MONTGOMERY COUNTY HISTORIC PRESERVATION COMMISSION
STAFF REPORT

Address:	15 W. Irving St., Chevy Chase	Meeting Date:	07/26/17
Resource:	Contributing Resource Chevy Chase Village Historic District	Report Date:	07/19/17
Applicant:	Franz & Alex Dreesgross	Public Notice:	07/12/17
Review:	HAWP	Tax Credit:	n/a
Case Number:	35/13-17V	Staff:	Dan Bruechert
Proposal:	Alterations to non-historic addition

② New Construction: Rear Elevation

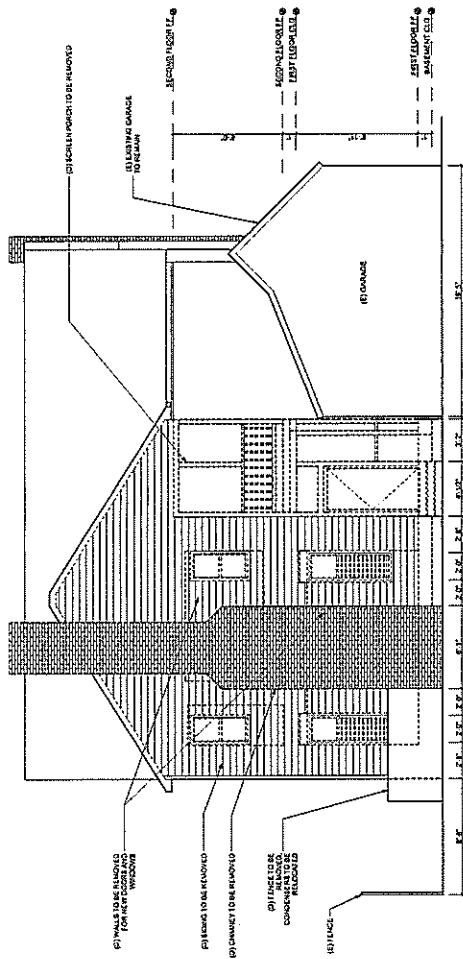
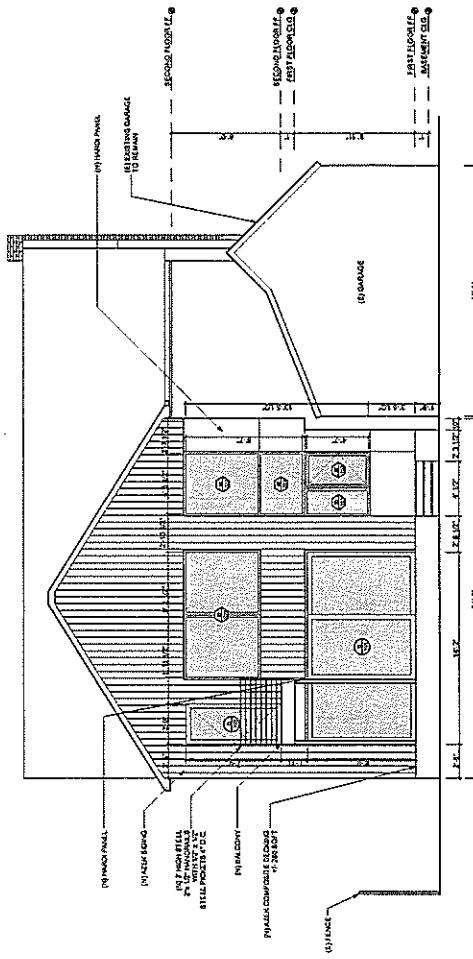
On the rear elevation, the applicant is proposing to remove the non-historic brick chimney and install several new windows, install a small balcony, and install vertical Hardi siding. All of these proposed alterations are on a non-historic portion of the house on an elevation that is not visible from the public right-of-way and the review is subject to lenient scrutiny.

The proposal will remove the four hung window, two on each floor, and replace them with large casement windows in steel frames. The ground floor will have two fixed, full-height windows and a sliding glass door of equal dimensions. The second floor will have a pair of large casement windows, each approximately 4'6" (four feet, six inches) square. On the left side of the second floor the applicant is proposing to remove the existing window and install a full-lite glass door with a small projecting balcony. District Guidelines state that balconies should be subject to lenient review if they are not visible from the public-right-of-way. The proposed 3' (three foot) tall balcony is 4'6" (four feet, six inches) wide and projects 3' (three feet) from the wall plane. Staff believe these changes will not have a significant impact on the historic building or the surrounding district.

The rear elevation of the screened-in porch will be glazed with large fixed windows in aluminum frames with smooth Hardi panels at the edges. These changes will have a visual impact on the rear elevation of the building, but do not affect the massing and scale of the building and are to be reviewed under lenient scrutiny. Lastly, this proposal will remove the Hardi clapboard siding and replace it with vertical Hardi siding. The overall effect of these changes will create a contemporary appearance on the rear elevation.

The District Guidelines state that aluminum and vinyl windows should be discouraged. Staff interprets this guidance to be focused on the installation of hung sash windows either as replacement windows or in new construction. The aluminum frame windows proposed in this HAWP are appropriate within a contemporary architectural vocabulary and Staff feels that the proposal is keeping with the stated policy promoting architectural excellence.
